DAMES & MOORE

March 19, 1974

Response to
 Review Questions on
 Environmental Report
 Moab Mill
 For Atlas Minerals Division
 Atlas Corporation

ATTACHMENT 2

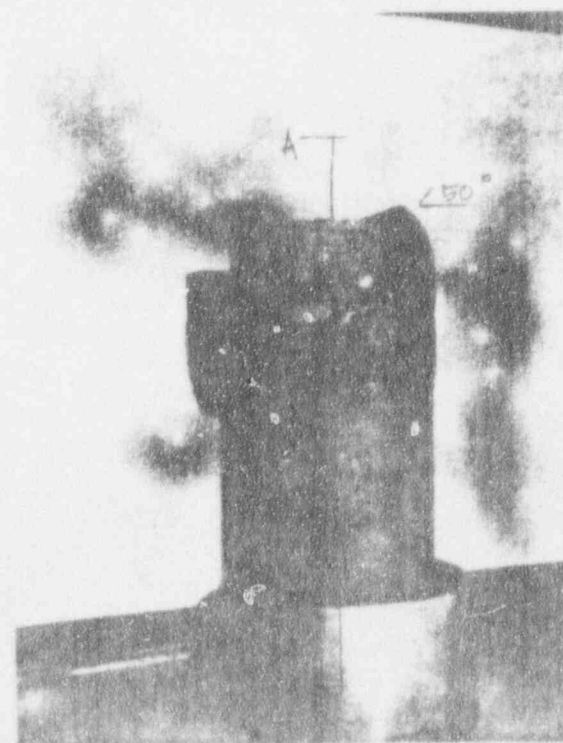
To present strength and density test results we are including, as Attachment 1, a stability analyses data sheet for our Section BB showing the typical friction angles and cohesion used for different portions of the slope. Attachment 2 shows a typical summary sheet for one of the triaxial tests with a photograph showing the method of failure of the sample.

ATTACHMENT 3

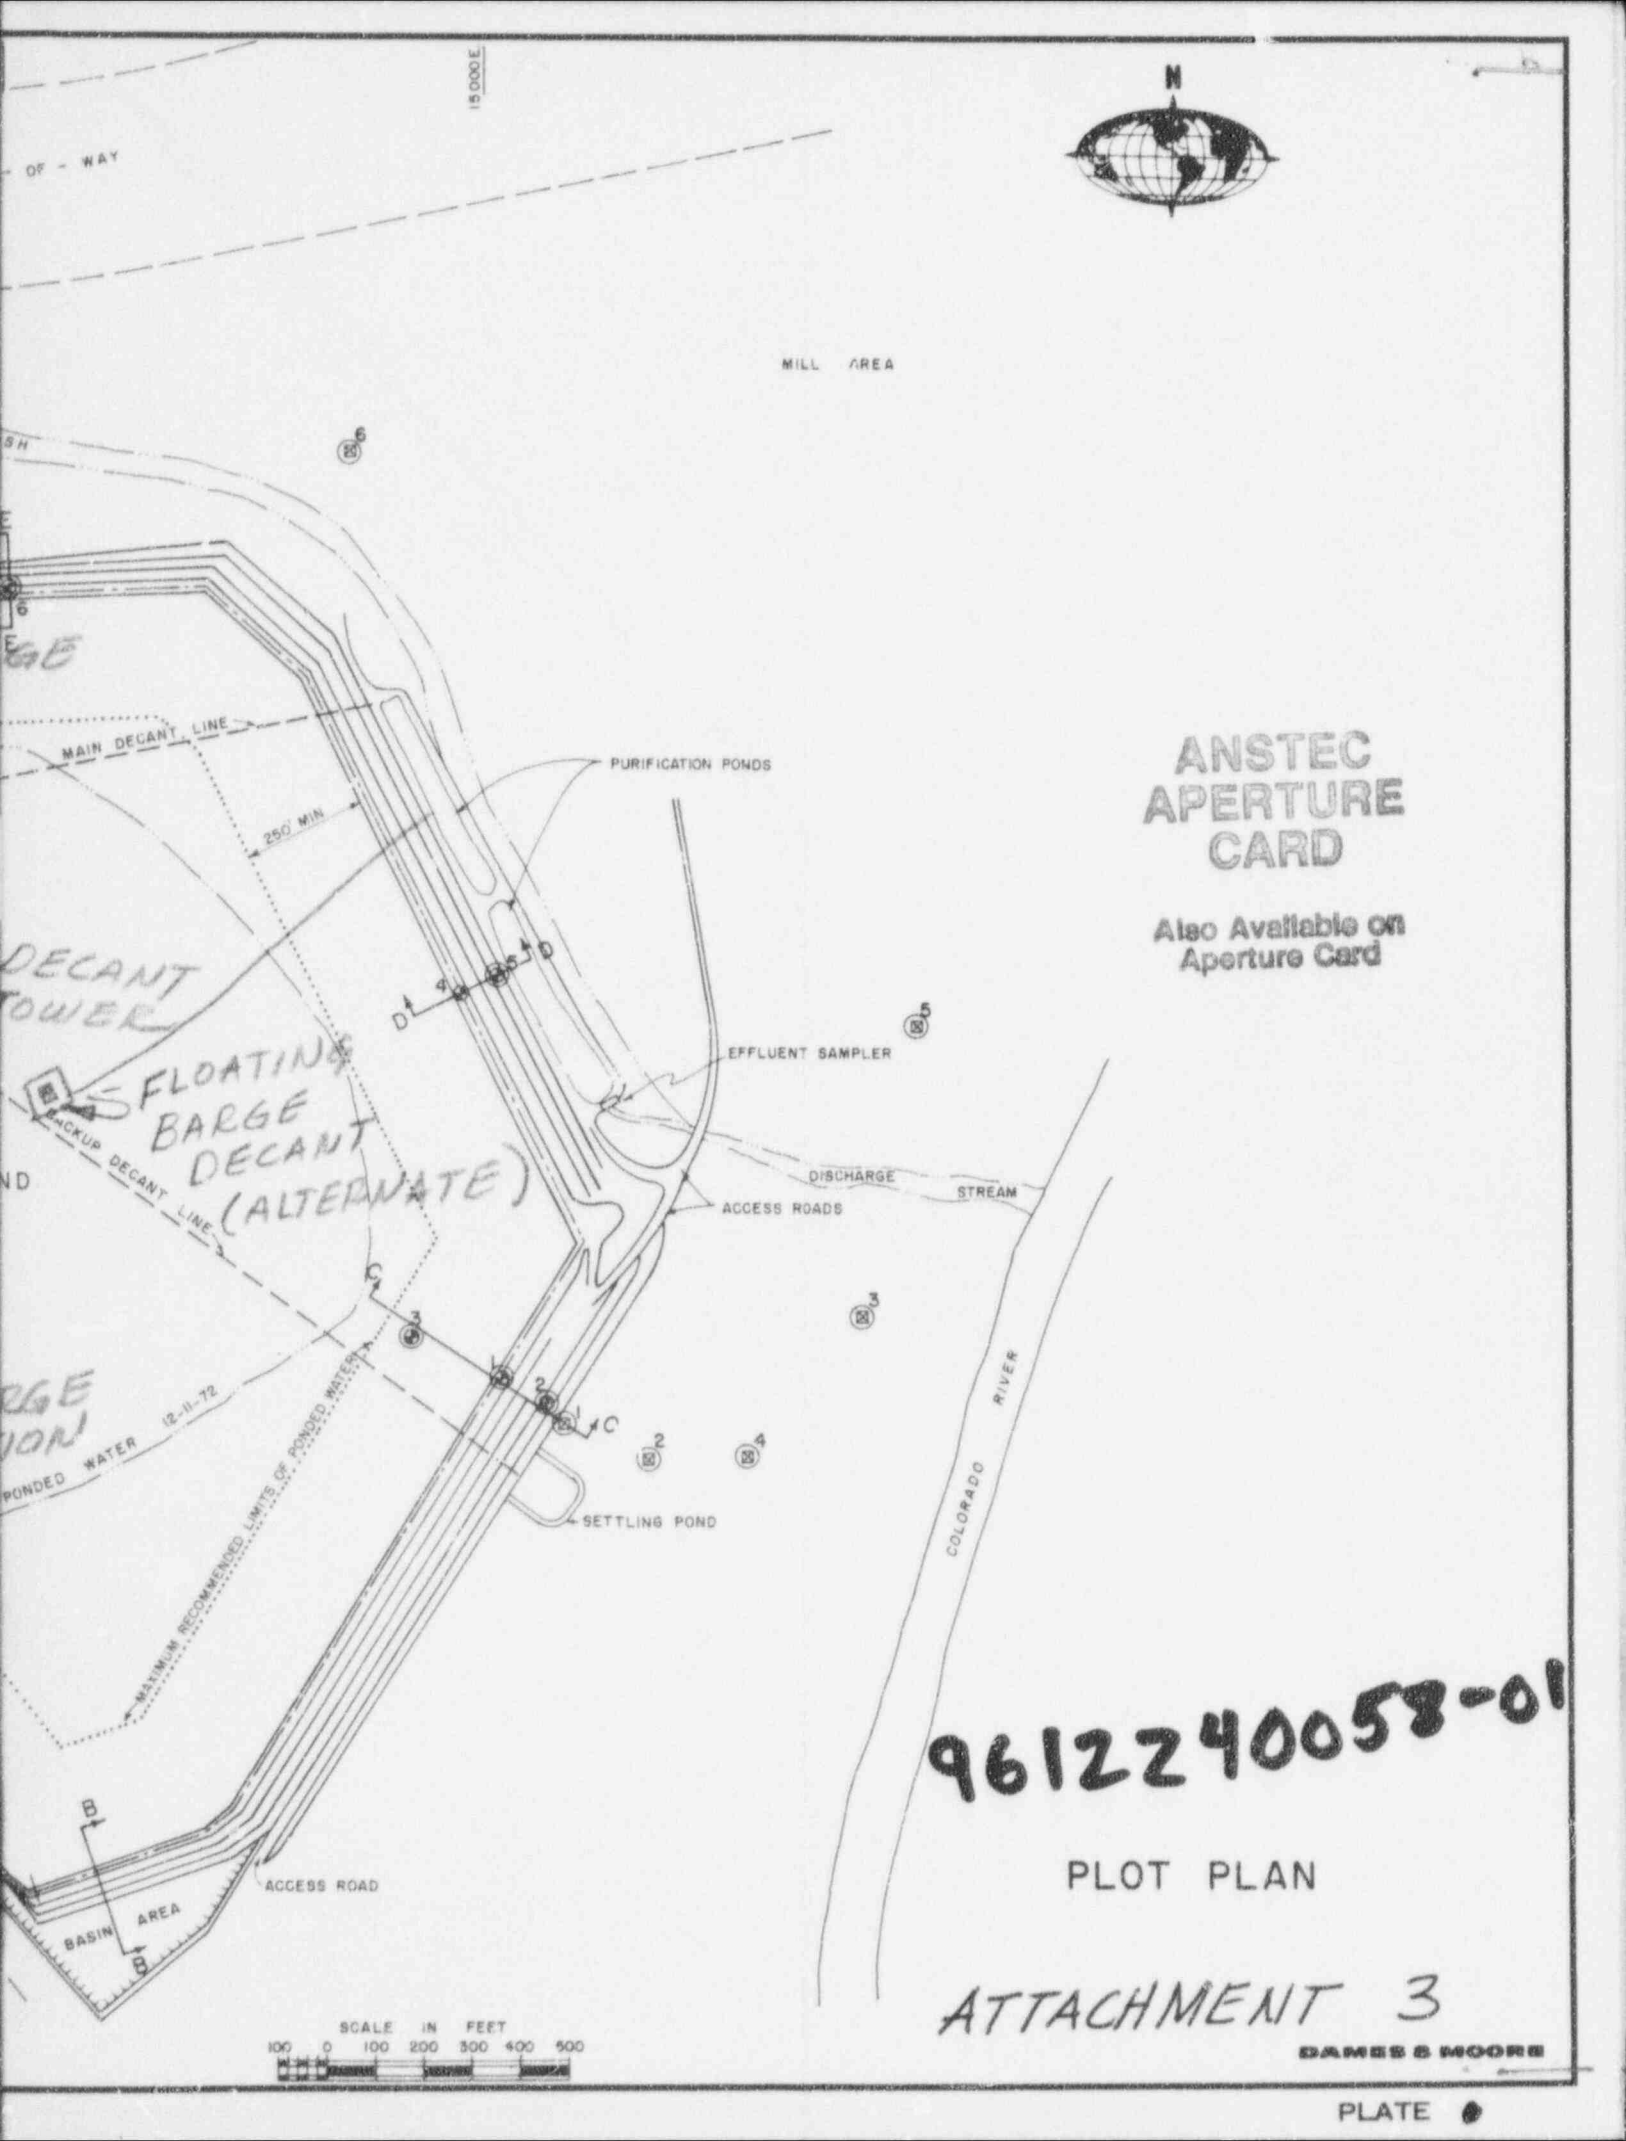
This question requests the location of the discharge line referred to on page 6.

This question concerns the proposed discharge and decant facilities and requests information on the basin area in the southern corner of the pond.

There appears to be an error in the quotation presented on page 6 as to the extent of the existing discharge line. The actual extent of the present line is shown on Plate 2 in the text of our report and as shown in black on Attachment 3.

Essentially, the discharge system will consist of extending the existing system to completely encompass the pond area. Initial discharging will be from the west area in order to build up that area and force the ponded water back into the center of the tailings pond area. A sketch of the discharge system is shown in red on Attachment 3.

The existing decant system will be altered in order to decant water from approximately the center of the ponded area. The location of a proposed tower is shown in blue on Attachment 3. Should difficulty arise in installing or operating the new decant tower, a pumping barge will be used to decant water from the central portion of the pond area over the embankment.

The basin area which is shown on the south end of the pond was designed for use as an alternate tailings storage area. This area has not been used for tailings storage in the past and will not be used for this purpose in the future.
